**FINAL DRAINAGE REPORT
FOR
LOT 5 OF CLEARWAY
EL PASO COUNTY, COLORADO**

SEPTEMBER 2022

Project #44-042

PCD Project No. PPR-22-034

DETENTION BASIN OUTLET STRUCTURE DESIGN

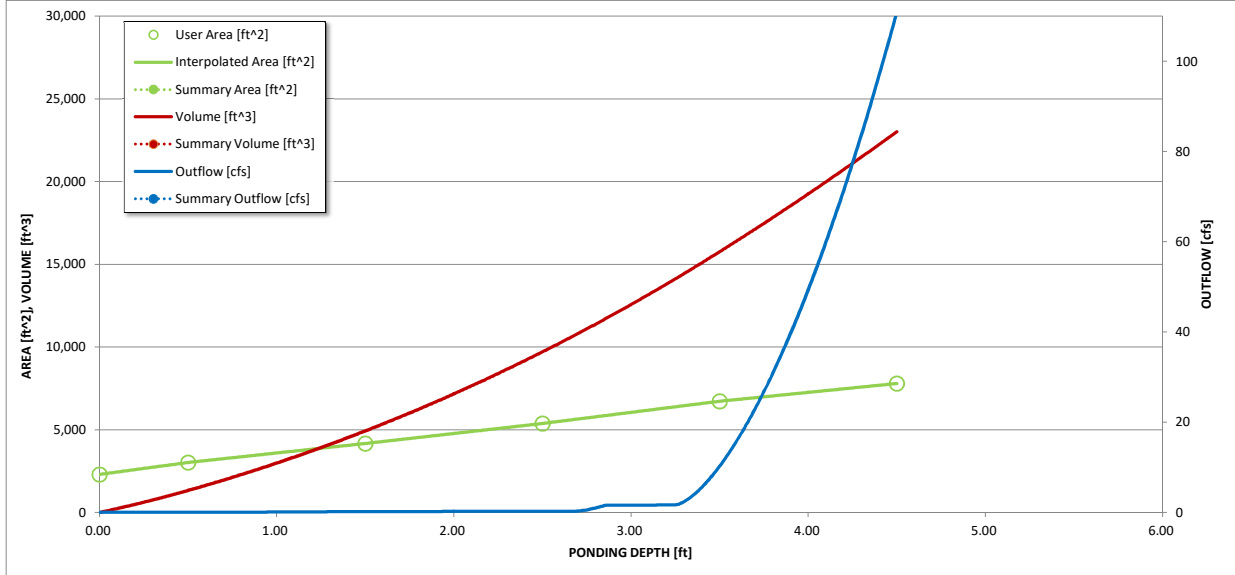
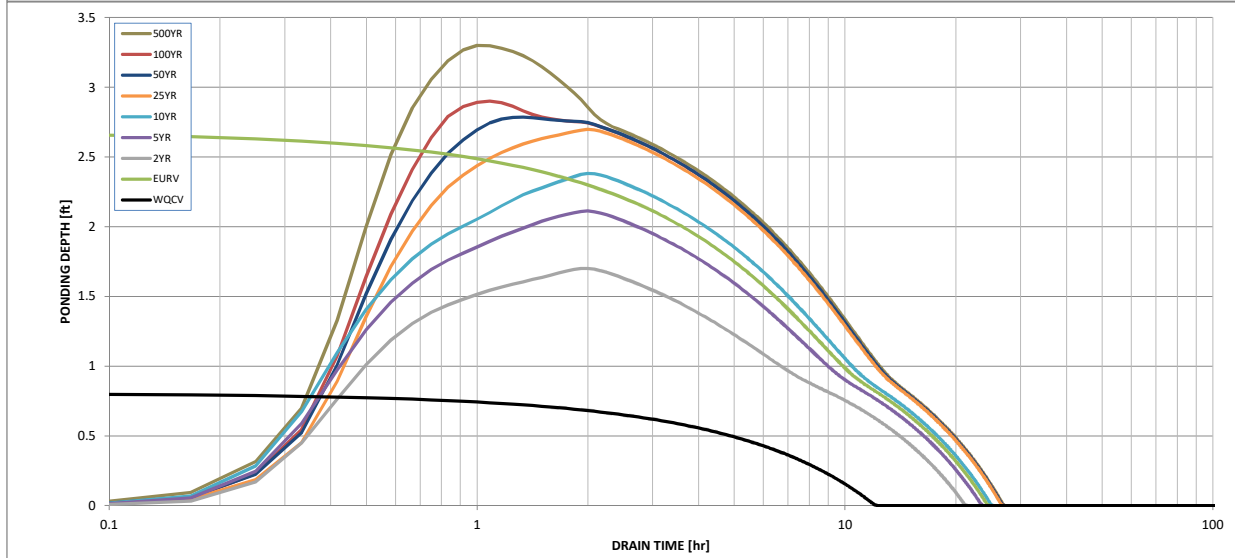
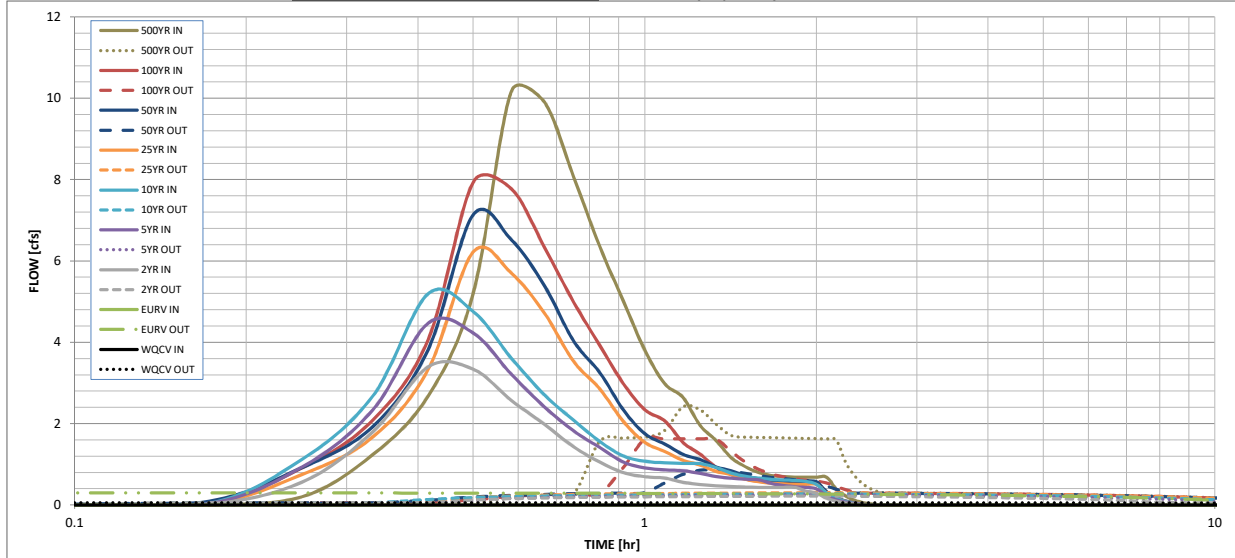
A 2"x2" orifice is identified in the CD. revise accordingly so that they are consistent with each other

orifice plate detail revised

Nyloplast 24" Standard Grate Inlet Capacity Chart

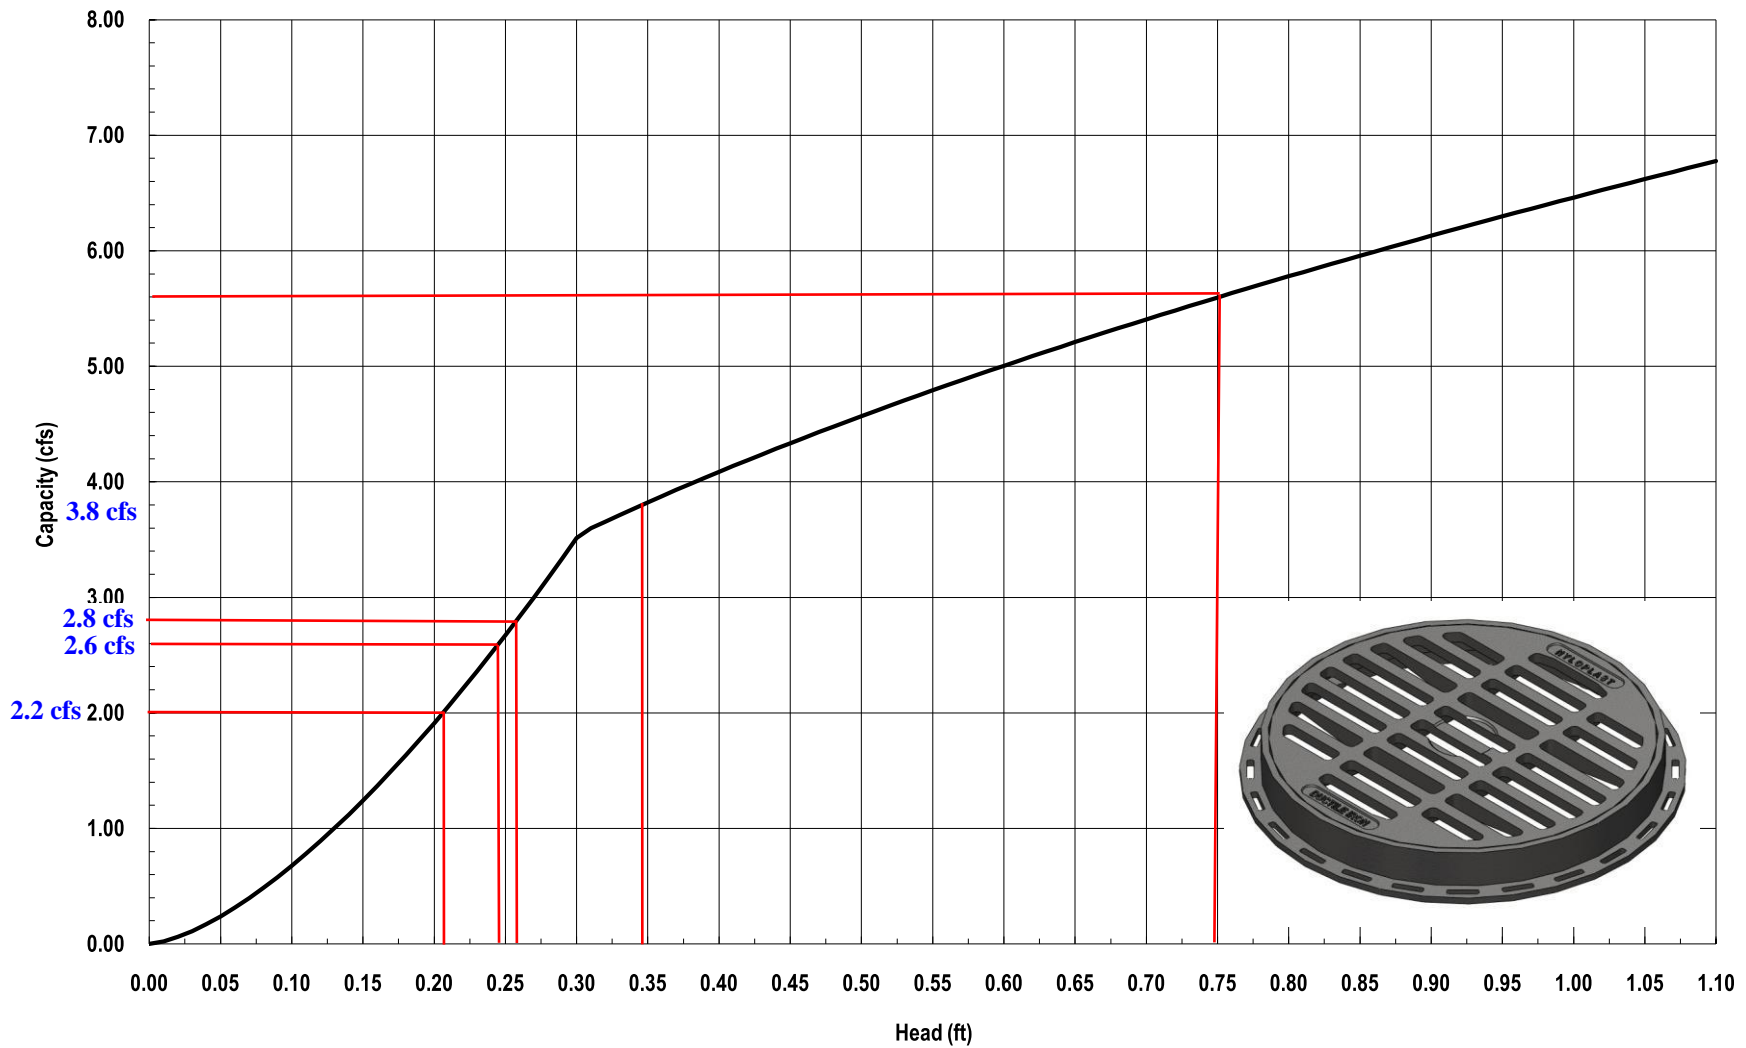
A 24" nyoplast grate inlet is shown on the plans. Please revise accordingly.

corrected

PROPOSED DRAINAGE MAP

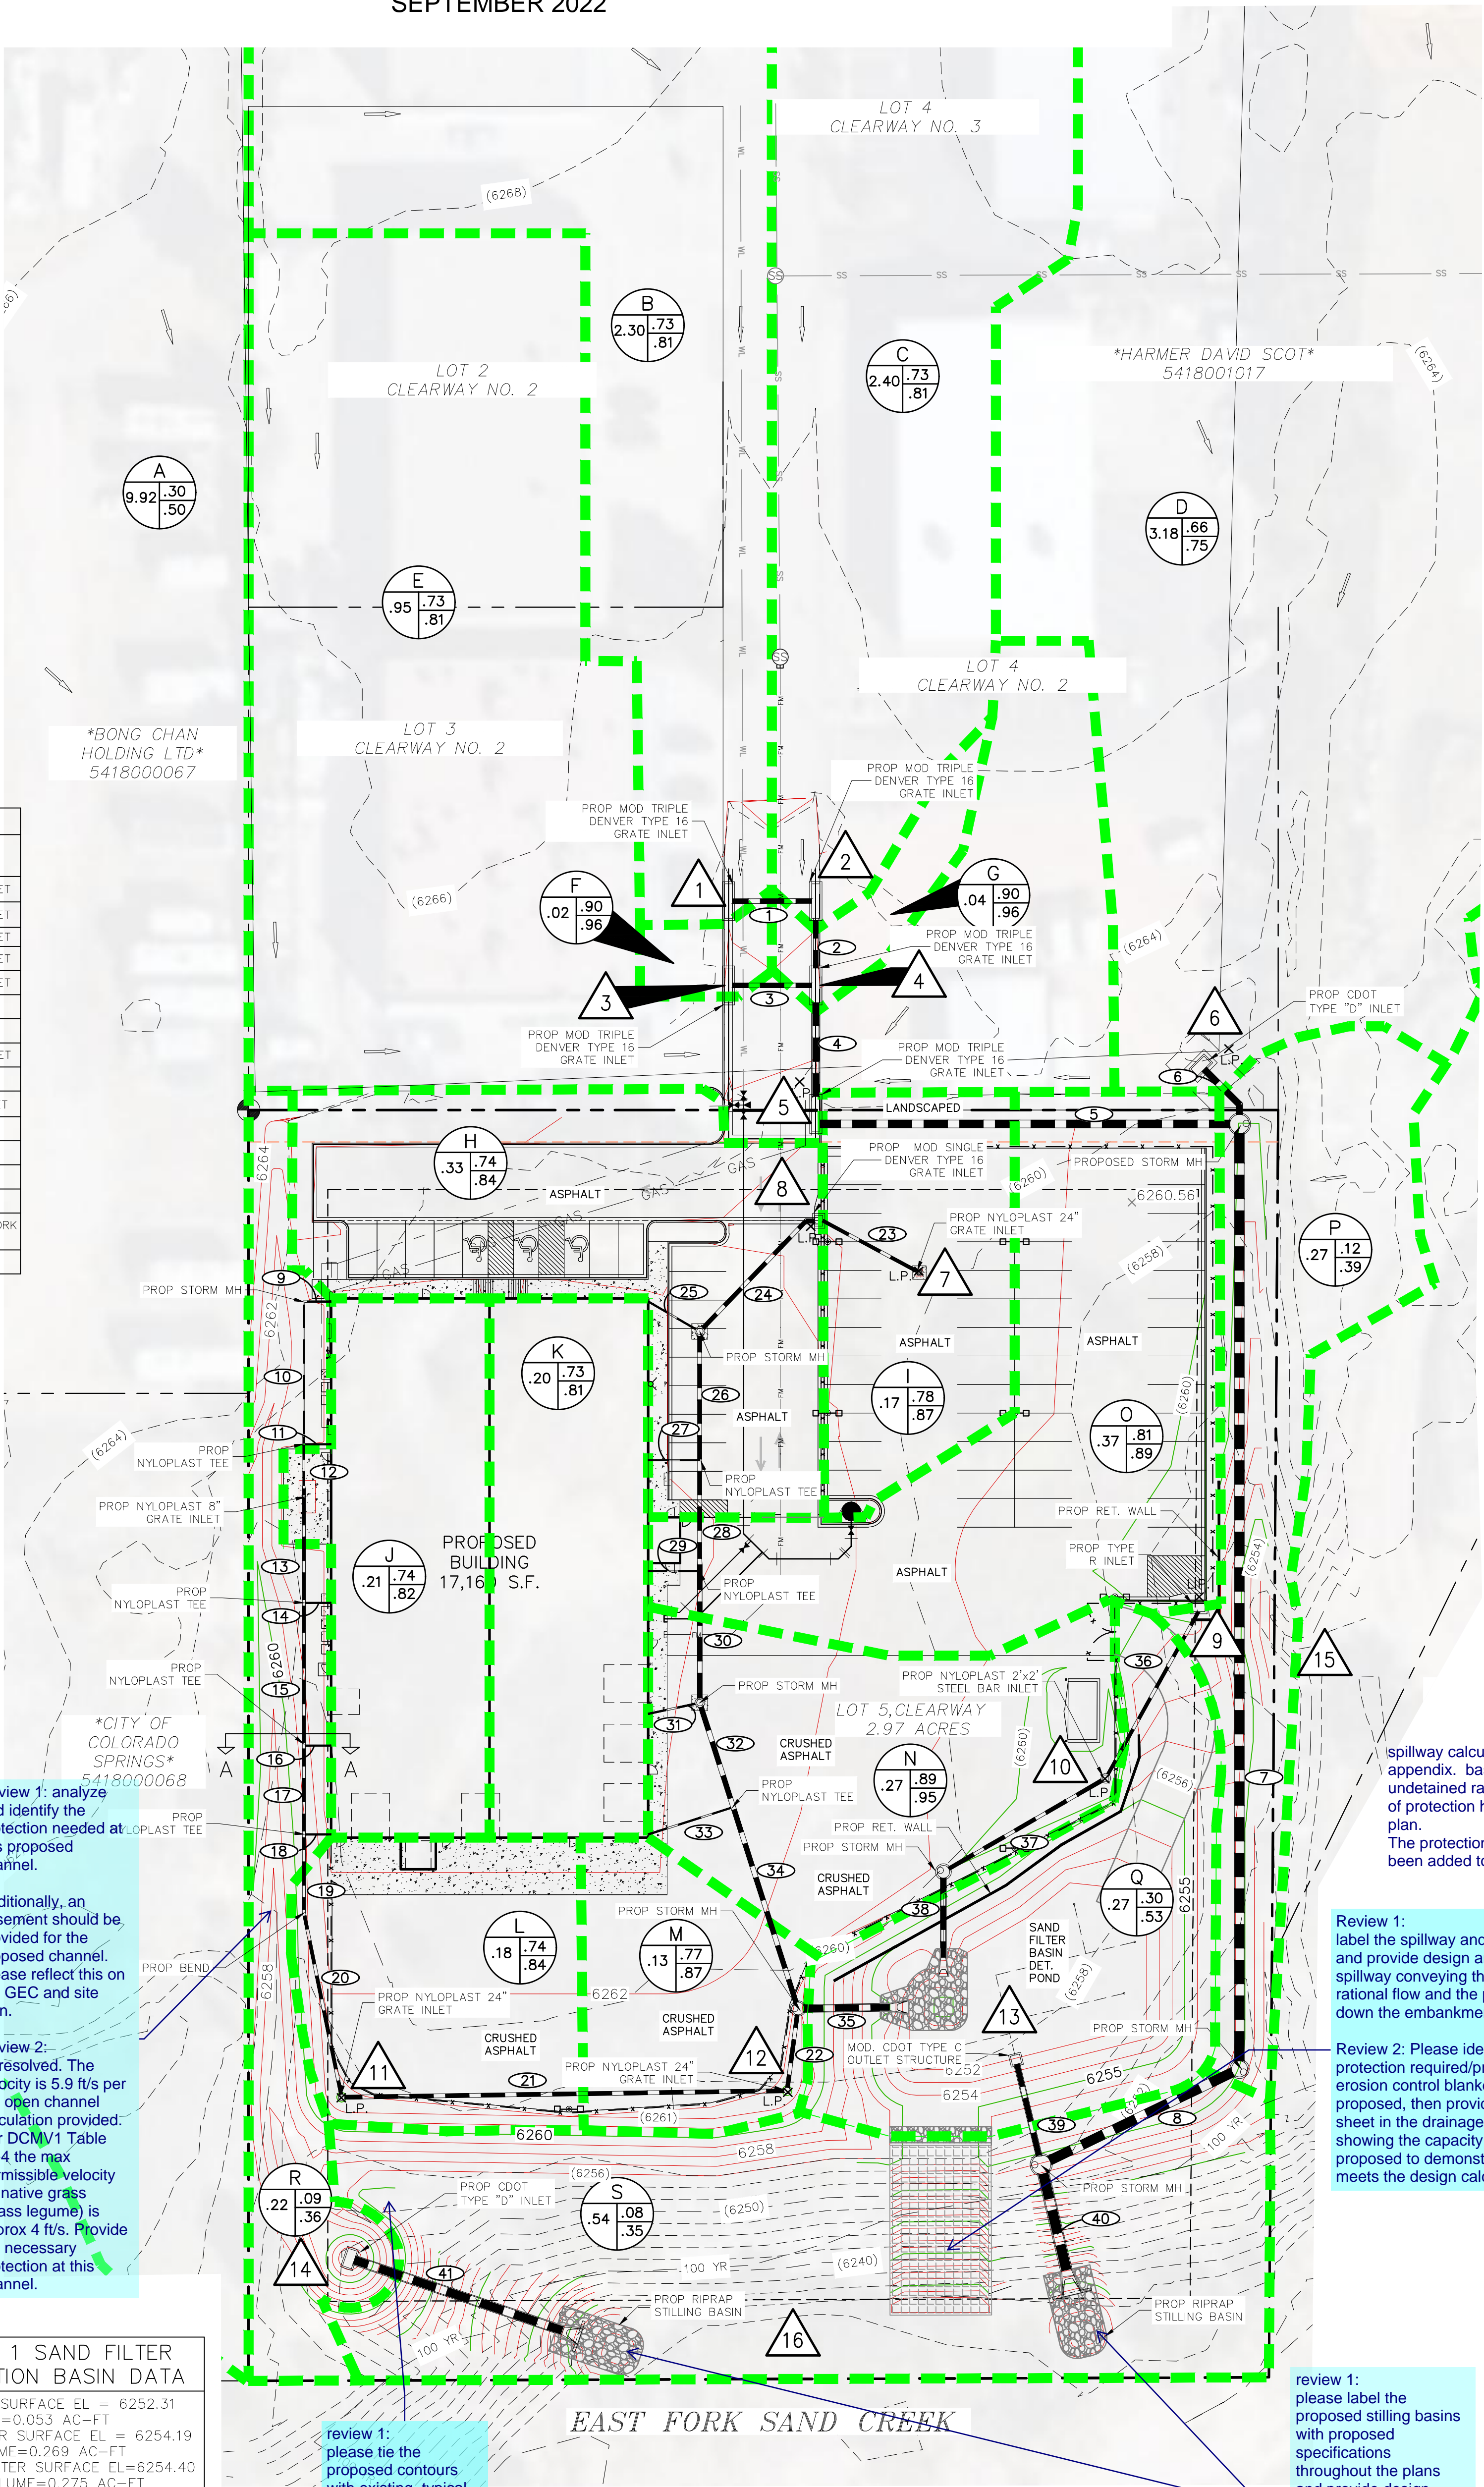
Additionally, an easement should be provided for the proposed channel. Please reflect this on the GEC and site plan.

Review 2: Unresolved. The velocity is 5.9 ft/s per the open channel calculation provided. Per DCMV1 Table 10-4 the max permissible velocity for native grass (grass legume) is approx 4 ft/s. Provide the necessary protection at this channel.

review 1: please tie the proposed contours with existing, typical throughout the plan

Review 1: label the spillway and protection and provide design analysis of the spillway conveying the undetained rational flow and the protection down the embankment.

Review 2: Please identify the protection required/provided. If erosion control blanket is proposed, then provide the spec sheet in the drainage report showing the capacity of the ECB proposed to demonstrate that it meets the design calculation.

review 1: please label the proposed stilling basins with proposed specifications throughout the plans and provide design analysis

Review 2: Unresolved. Provide the nomograph/detail used for the design of the stilling basin in the report. Additionally identify the riprap size.

proposed and existing contours now both set at 10' and 2' increments. previously 1' and 5' proposed contours were shown on the plan

The detail has and will continue to be provided in the plans. The appropriate callouts have been added to this sheet which specify the construction materials/sizes. The standard detail is provided in the plans, is not also included in the report. This is a standardized detail based upon pipe size. There is no additional analyzing required.

spillway calculation provided in appendix. based upon the undetained rational flow. the type of protection has been added to the plan. The protection spec sheet has been added to the appendix.
